Product Change Notification

PCN-10624

ODD, DAD, DDA, DDB, DDC, XDA, and XDB Series Design Improvement

14 August 2023

New Right-Angle Connector

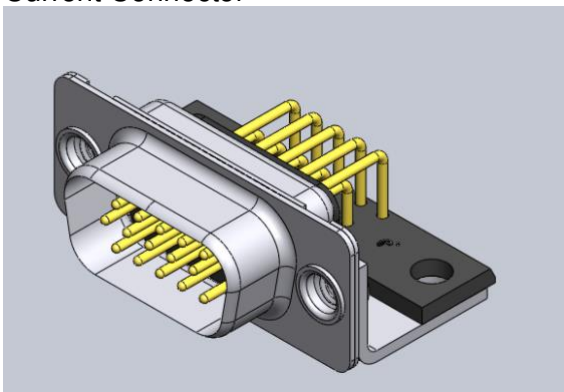
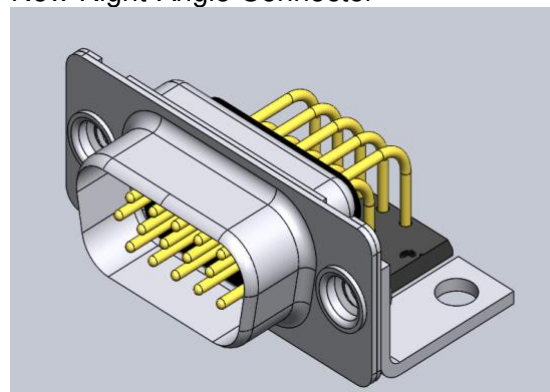
Printed board mount contacts shall be designed to use the larger bend radius to improve manufacturability. Board and mating dimensions are not affected.

Alignment bar will be shortened.

Current Female Solder Cup Contacts
(Shorter Tails)

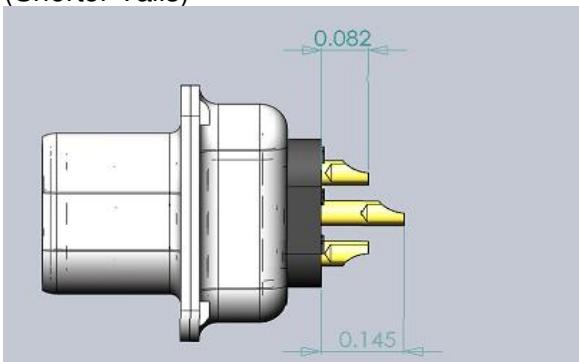
Solder cup contacts will increase in termination length.
